**August 1, 2014**  
**BOARD OF COUNTY COMMISSIONERS**  
**ORANGE COUNTY, FLORIDA**

**ADDENDUM NO. 4**  
**IFB NO. Y14-748**  
**ORANGE COUNTY EASTERN WATER RECLAMATION FACILITY**  
**PHASE V AND CENTRIFUGE DEWATERING IMPROVEMENTS**

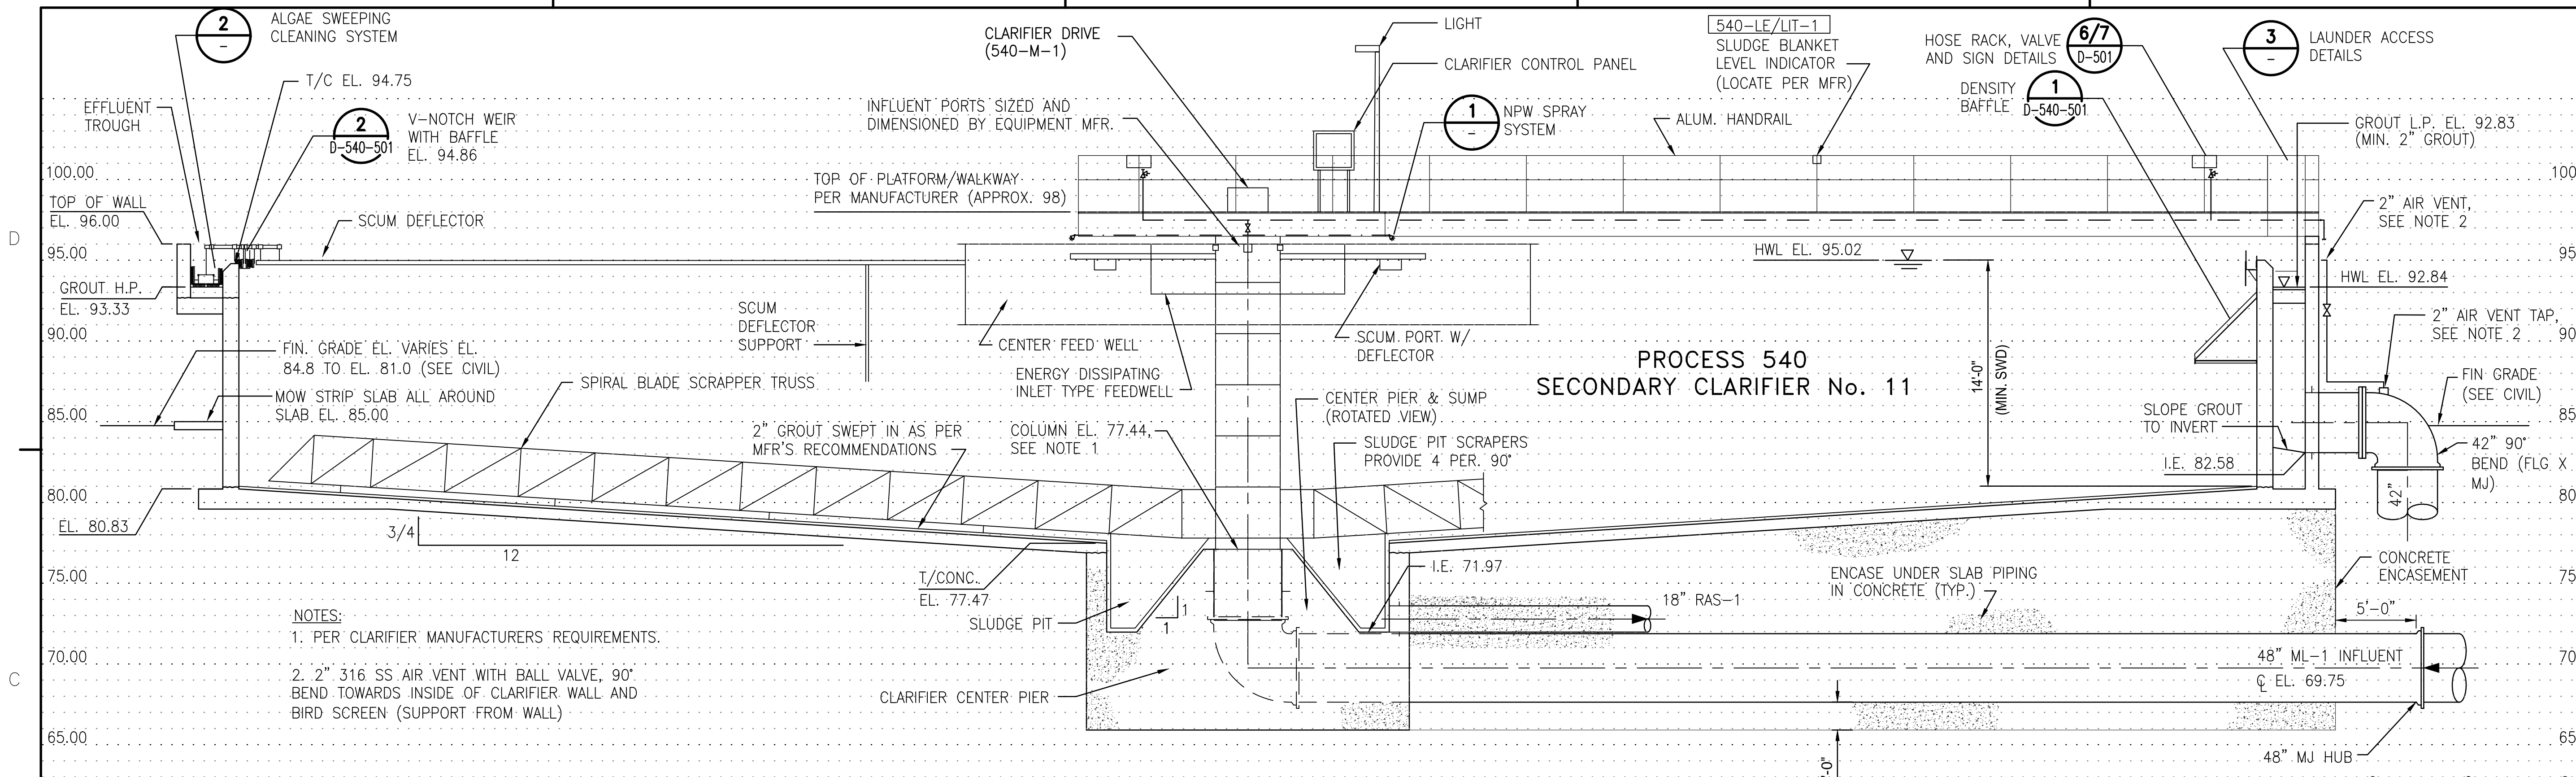
22. Refer to Bid Package A. Reference Drawing D-520-101, 301. Are the 4" butterfly valves on the suction lines at the tanks to be CPVC? If so, please provide a specification.

*Reference Bid Package A, Drawing D-520-101. Provide Type 314 ball valves in lieu of the butterfly valves shown (**Attachment**). In addition, Type 314 – Double Union CPVC Ball Valves 4 Inches and Smaller has been*

**A SECTION**  
D-540-101 SCALE: 3/16"=1'-0"

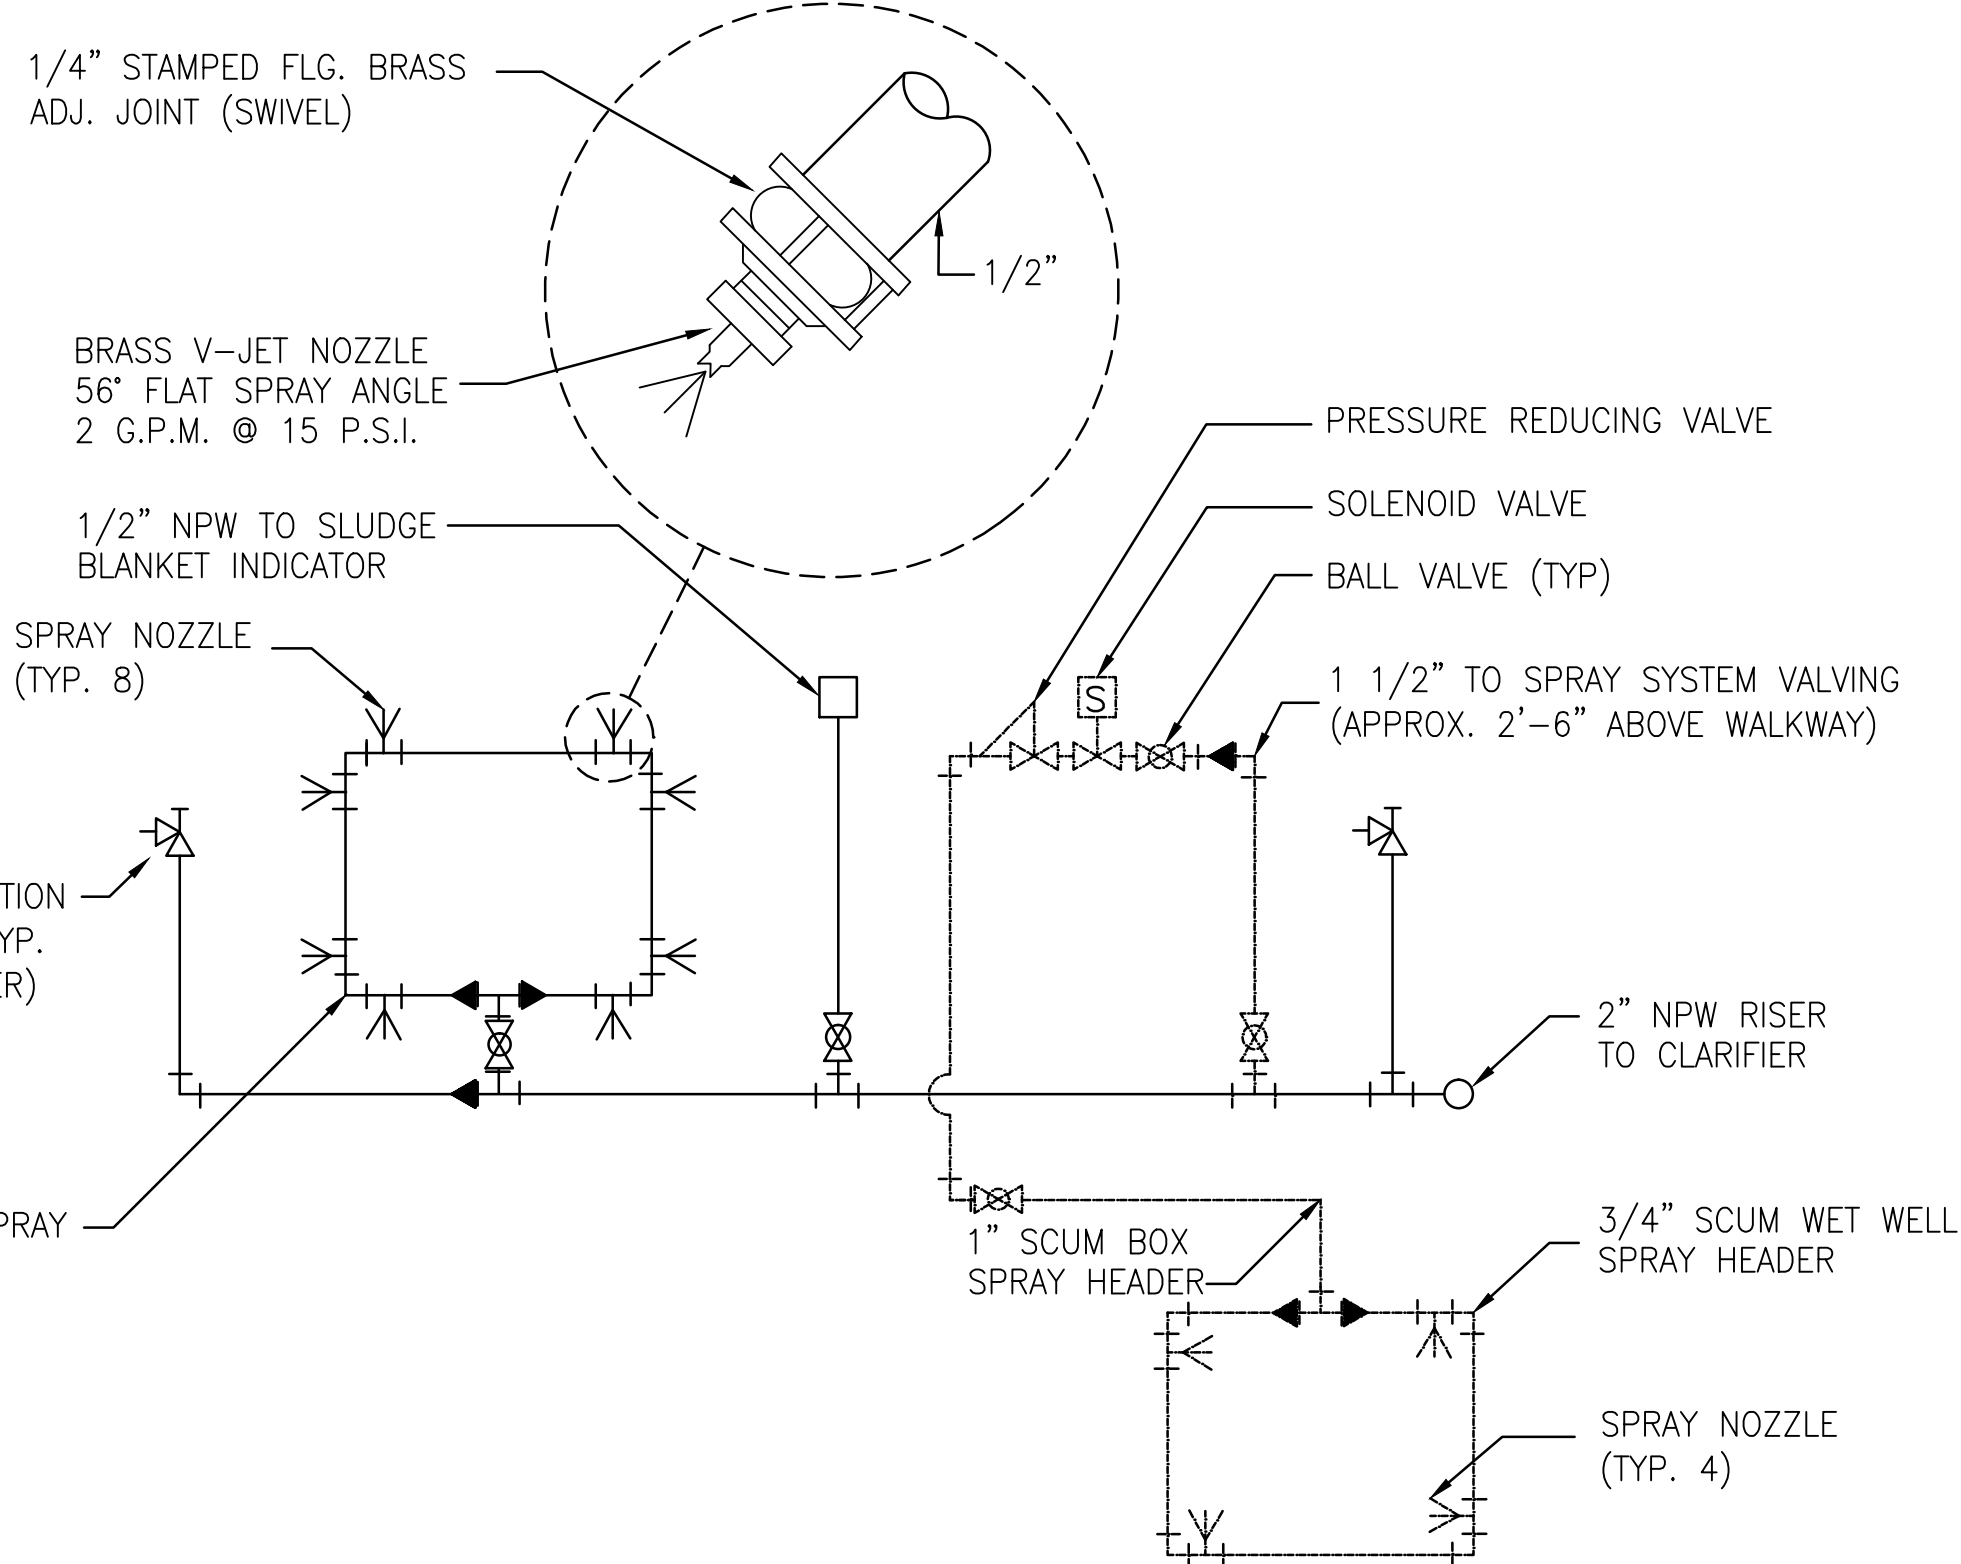
83. Reference Bid Package A, Process 540 - Please Detail the SE-1 Point of Connection at Clarifier 11 (Process 540), sheet D-540-301 shows the connection with a 90 bend, sheet C-126, callout 275 calls for a Tee. If a Tee is required, we would assume that it will be blind flanged off with an ARV in lieu of the 90 w/ARV as shown in Section A/D-540-301. Please clarify the connection, and show a section view.

84. Reference Bid Package A, Process 540 - Will the SE-1 Connection at Clarifier 11 be Flanged or Mechanical Joint as called out in section A/D-540-301? The pipe is shown on sheet D-540-301, section A as being half in, and half out of the ground.

*Please reference Drawing C-126; zone C3 which shows a 42" tee at callout 275. To the east of the 42" tee is a 42" 90-deg bend turned up. The 90-deg bend on Drawing D-540-301, zone D5 is another 42" 90-deg bend turned down. The civil drawings show the buried fittings at elevation 76.75. Drawing D-540-301 shows the upper fitting at elevation 85.00*

*The proposed finished grade in this location is 84.50 per Drawing C-137. The centerline of the 42" 90-deg angle bend is at elevation 85.00 per Drawing D-540-301. The 42" 90-deg angle bend should be flanged with a boss for the 2" manual air release valve (**Attachment**).*
